# UNITED STATES PATENT AND TRADEMARK OFFICE

<b>Office Action Summary</b>	<b>Application No.</b> 10/581,720	<b>Applicant(s)</b> SHIMADA, TOSHIKI	
	<b>Examiner</b> JUSTIN KRAUSE	<b>Art Unit</b> 3656

## **DETAILED ACTION**

FIG. 7

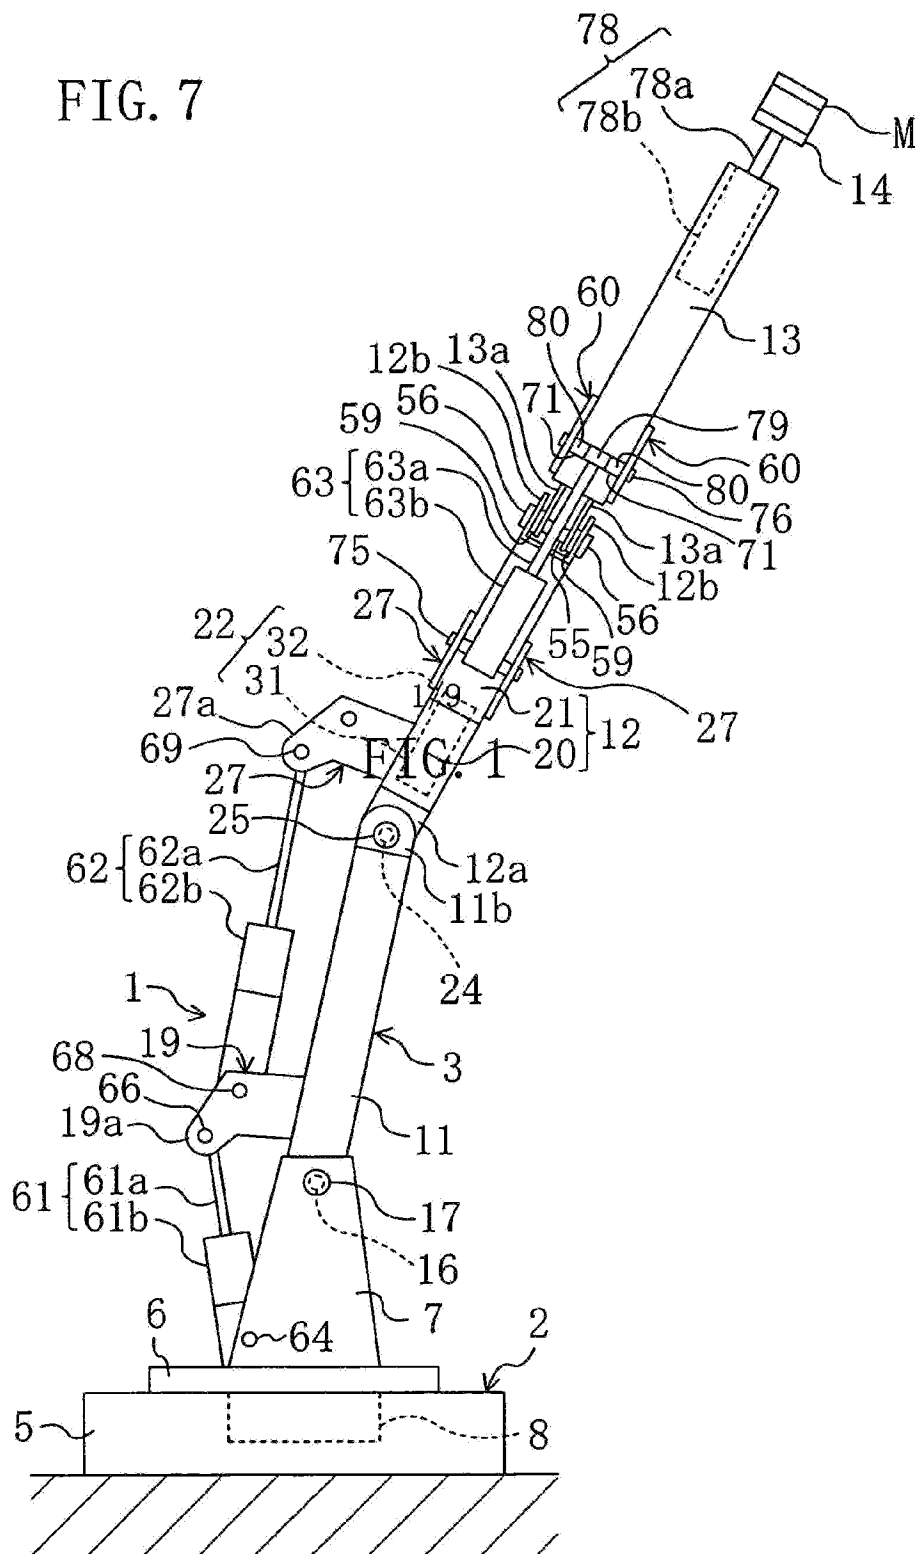
The drawings are objected to because Figure 7 as currently filed includes "1/9" and "FIG.1" in the center of the drawing (the image below depicts figure 7 as presently filed). Corrected drawing sheets in compliance with 37 CFR 1.121(d) are required in reply to the Office action to avoid abandonment of the application. Any amended replacement drawing sheet should include all of the figures appearing on the immediate prior version of the sheet, even if only one figure is being amended. The figure or figure number of an amended drawing should not be labeled as "amended." If a drawing figure is to be canceled, the appropriate figure must be removed from the replacement sheet, and where necessary, the remaining figures must be renumbered and appropriate changes made to the brief description of the several views of the drawings for consistency. Additional replacement sheets may be necessary to show the renumbering of the remaining figures. Each drawing sheet submitted after the filing date of an application must be labeled in the top margin as either "Replacement Sheet" or "New Sheet" pursuant to 37 CFR 1.121(d). If the changes are not accepted by the examiner, the applicant will be notified and informed of any required corrective action in the next Office action. The objection to the drawings will not be held in abeyance.
